Urban Design Study for the Wan Chai North and  
North Point Harbourfront Areas  
灣仔北及北角海濱城市設計研究

Stage 2 Public Engagement  
Written Comments Received

**List of Organisations submitting Written Comments  
during the Stage 2 Public Engagement (PE2)**

**ROUTE OPTIONS OF CYCLEWAY NEAR TYPHOON SHELTER 單車走道近避風塘路線選項**

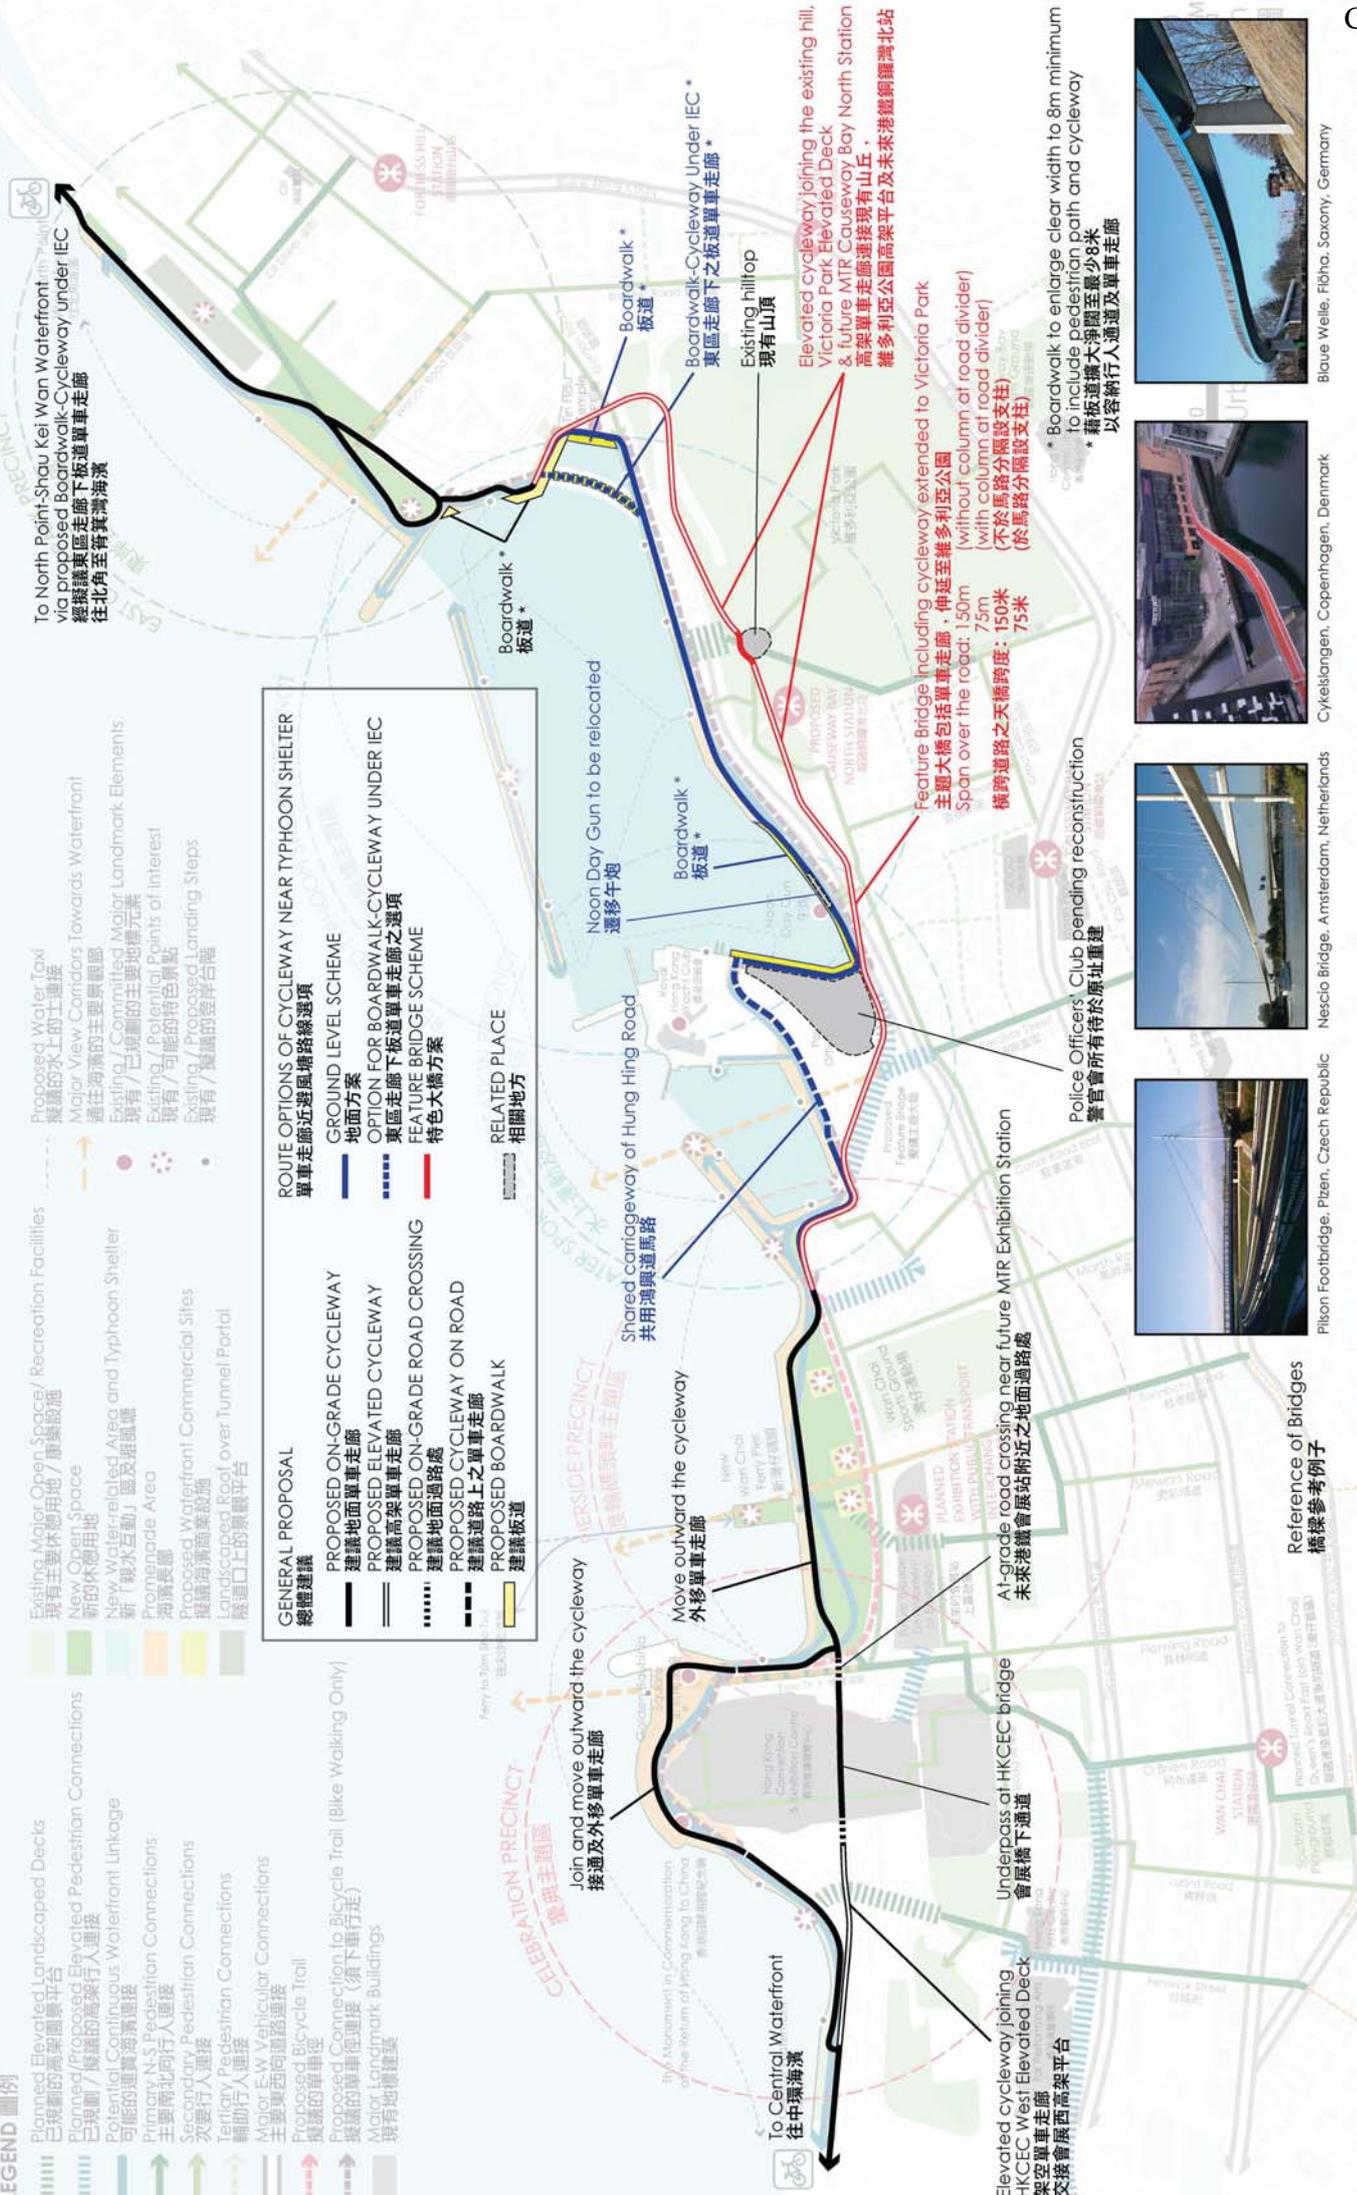
#### Proposed revised cycleway alignment

Please see attached plan of proposed cycleway alignment options. Notable aspects, west to east:

**Figure 1**  
Harbourfront Enhancement Proposals  
優化海濱建議

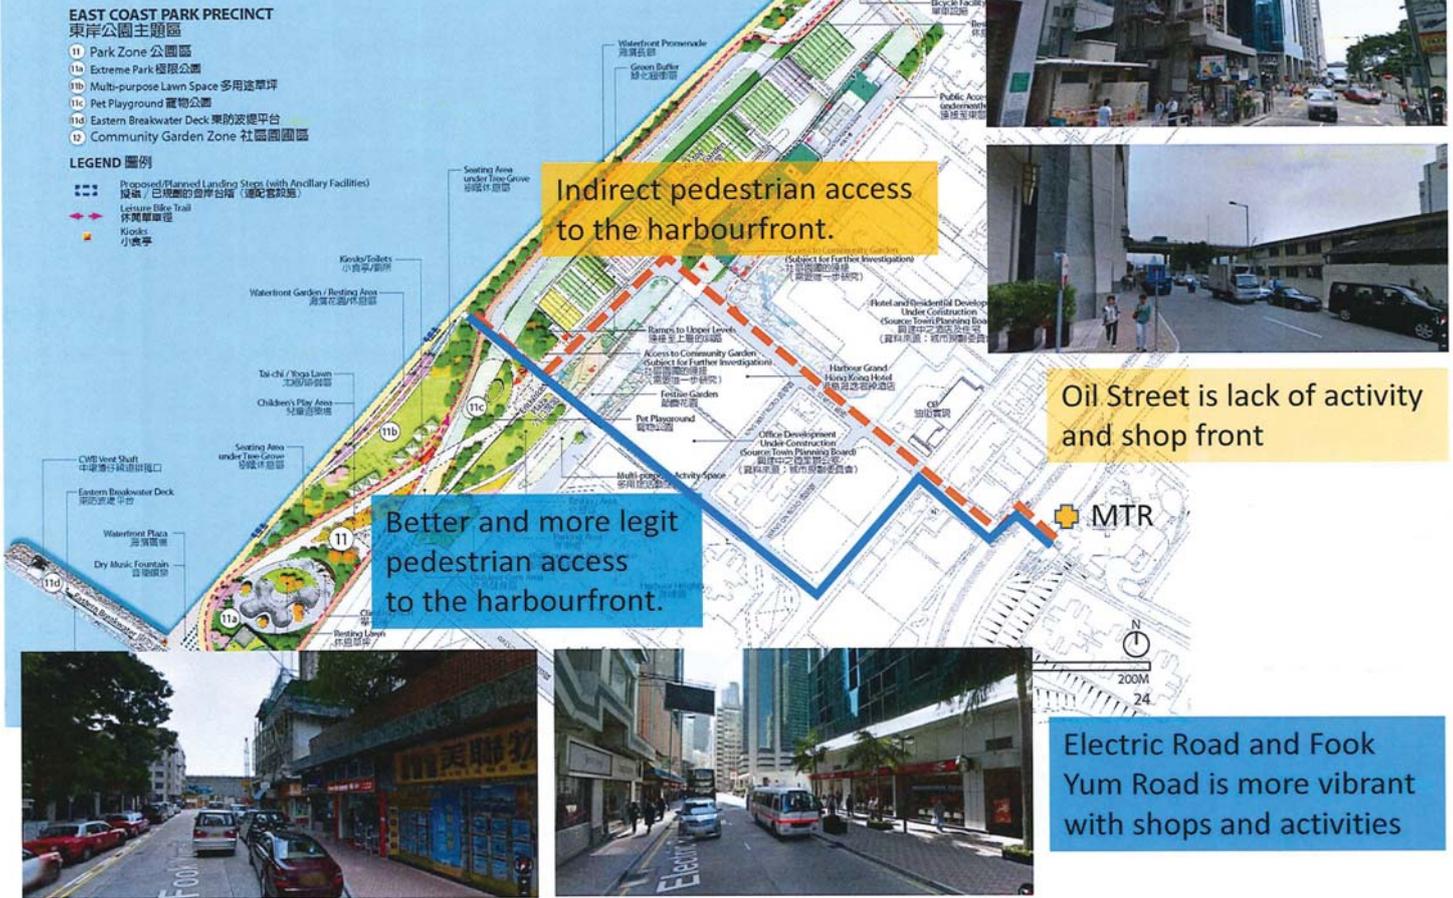
Currently, pedestrian access to the harbourfront from Fortress Hill Station is indirect (**Figure 1**). There is no activity attracting pedestrian along Oil Street. The proposed Community Garden may obstruct a legit visual corridor and access to the harbourfront along Oil Street. On the contrary, the Electric Road and Fook Yum Road are more vibrant with activities and shops along. As pedestrian, the experience is better because it is more direct to harbourfront, and the visual and activity corridor draw our attention.

3. Sunset Plaza 日落廣場

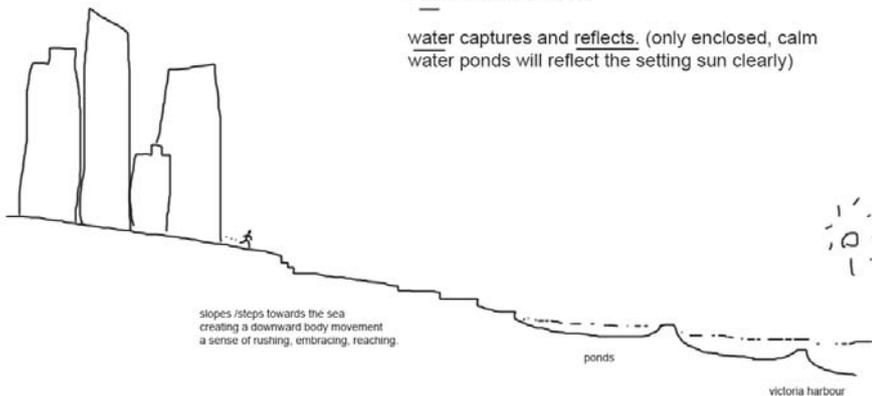
see, even your rendering shows it...i'm not engaging with the water. i won't embrace the setting sun...

PIERSIDE PRECINCT  
渡輪碼頭畔主題區

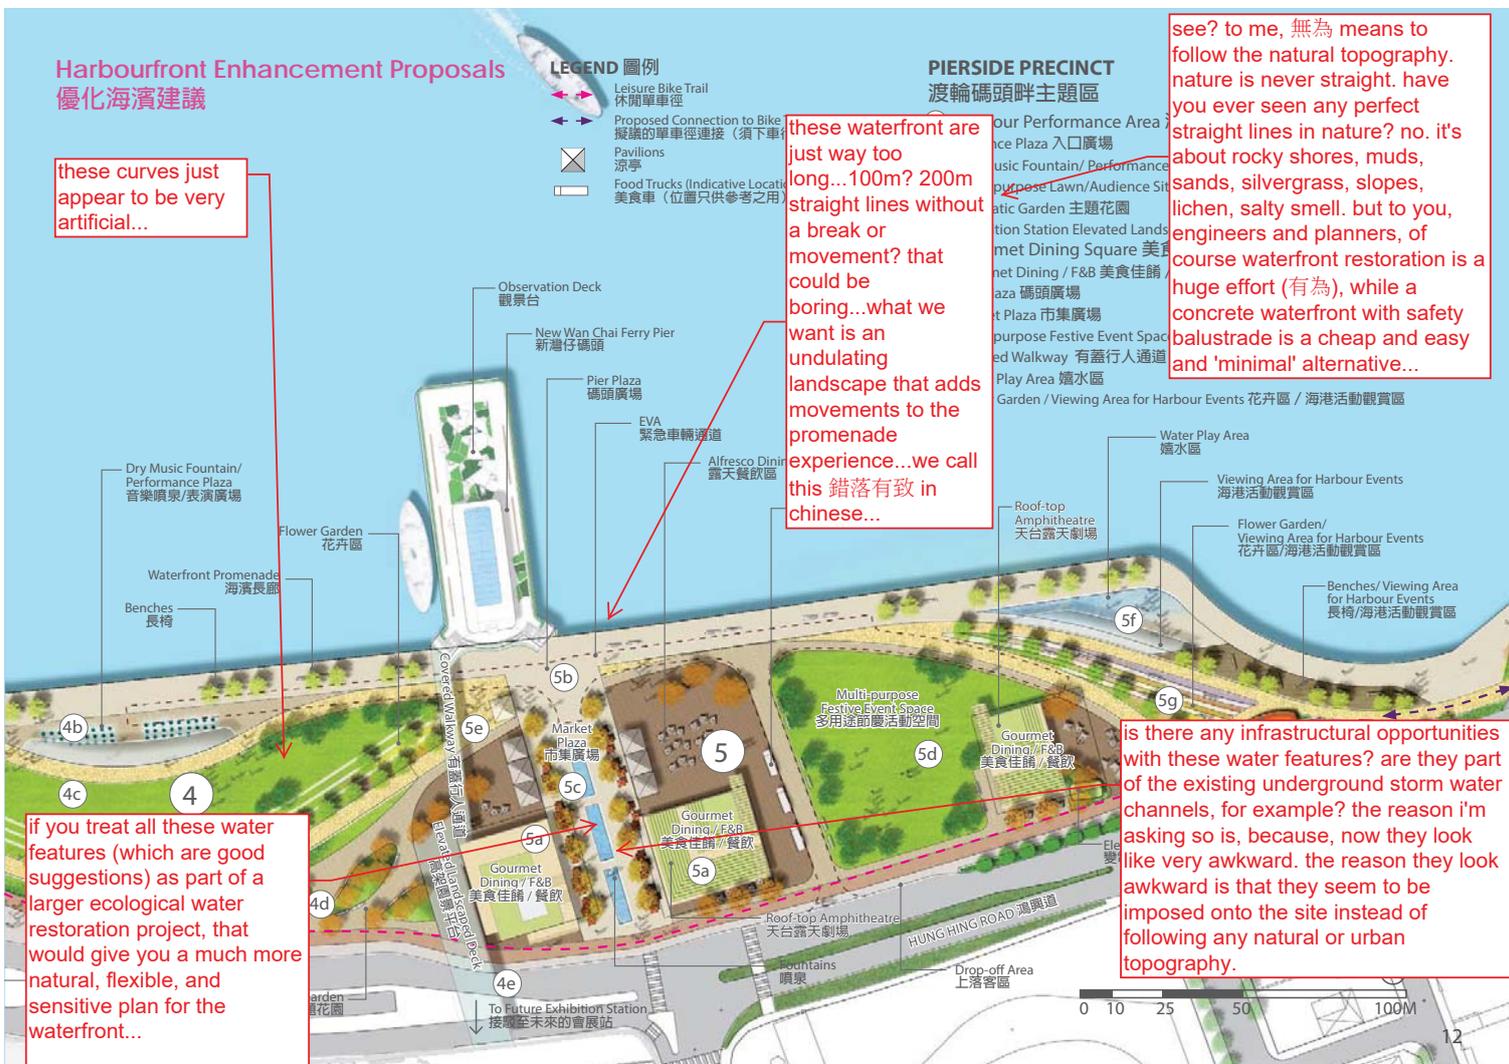
these curves just appear to be very artificial...

these waterfront are just way too long...100m? 200m straight lines without a break or movement? that could be boring...what we want is an undulating landscape that adds movements to the promenade experience...we call this 錯落有致 in chinese...

see? to me, 無為 means to follow the natural topography. nature is never straight. have you ever seen any perfect straight lines in nature? no. it's about rocky shores, muds, sands, silvergrass, slopes, lichen, salty smell. but to you, engineers and planners, of course waterfront restoration is a huge effort (有為), while a concrete waterfront with safety balustrade is a cheap and easy and 'minimal' alternative...

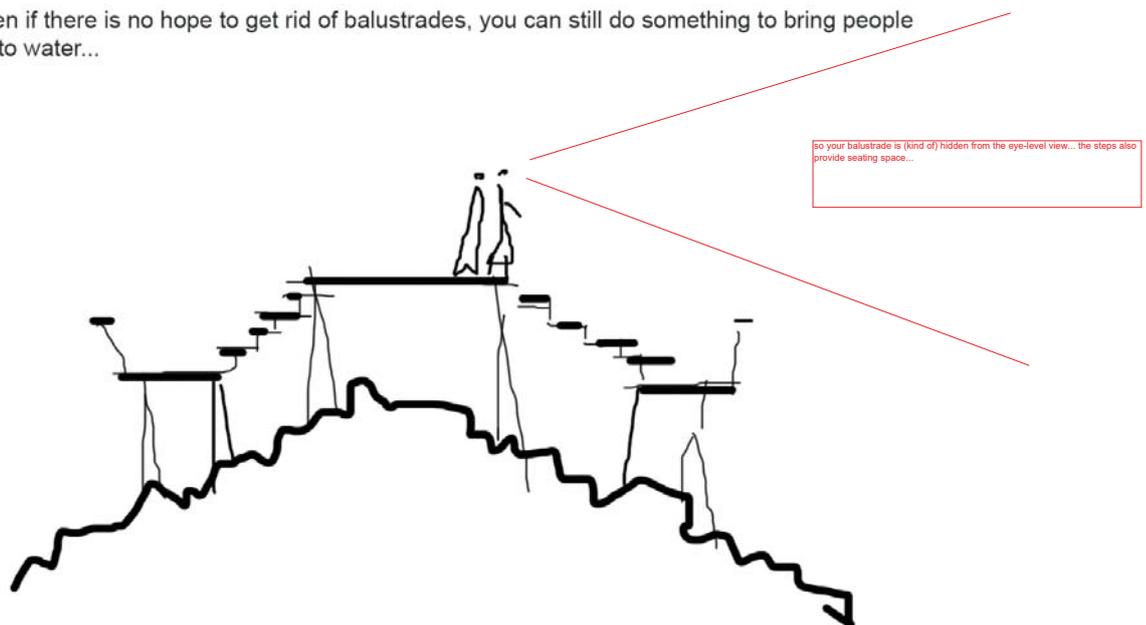
i know district councillors love waterfront balustrades - it just seems they are inevitable in this place called hong kong.

but even if there is no hope to get rid of balustrades, you can still do something to bring people closer to water...

# APPENDIX 2

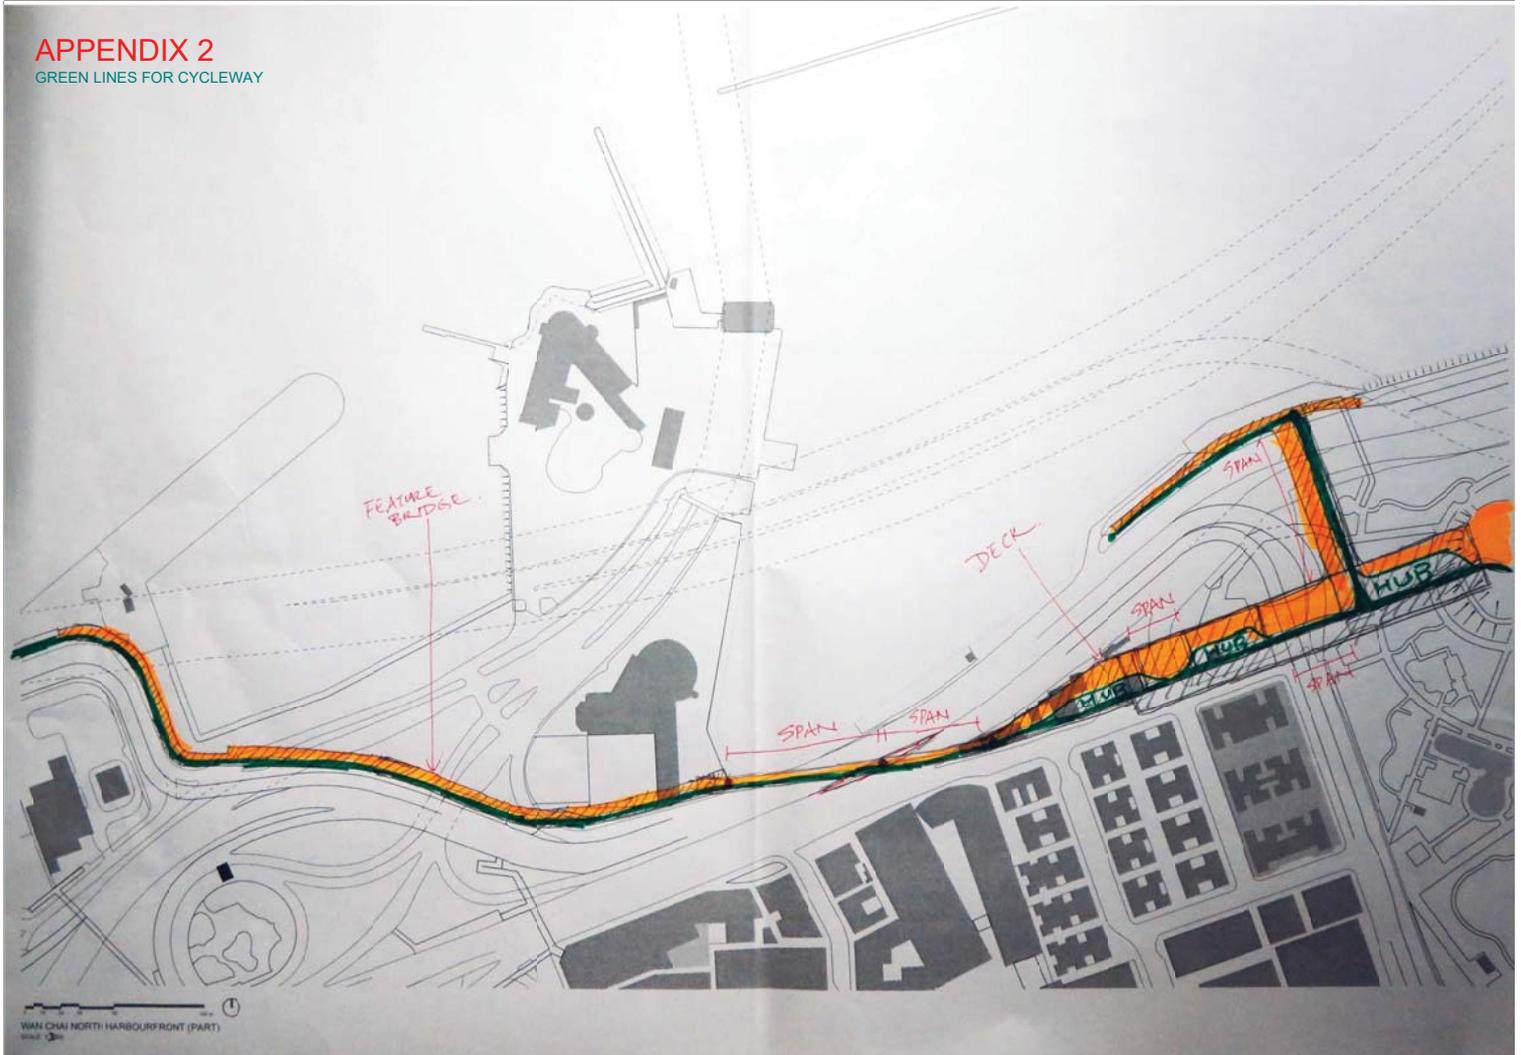
If the station follows the layout in the previously open schematic documents, particularly at the 'half inside Victoria Park' layout, the roof deck and superstructure have provided a possibility for bike facility hub, as well as the Feature Bridge extension towards the artificial hill at the Victoria Park. To preserve the development capacity, the scope of works for MTR Causeway Bay North Station of the North Island Line should include the landscaped decks with bike facilities and Feature Bridge.

(Refer to Appendix 2 & 3)
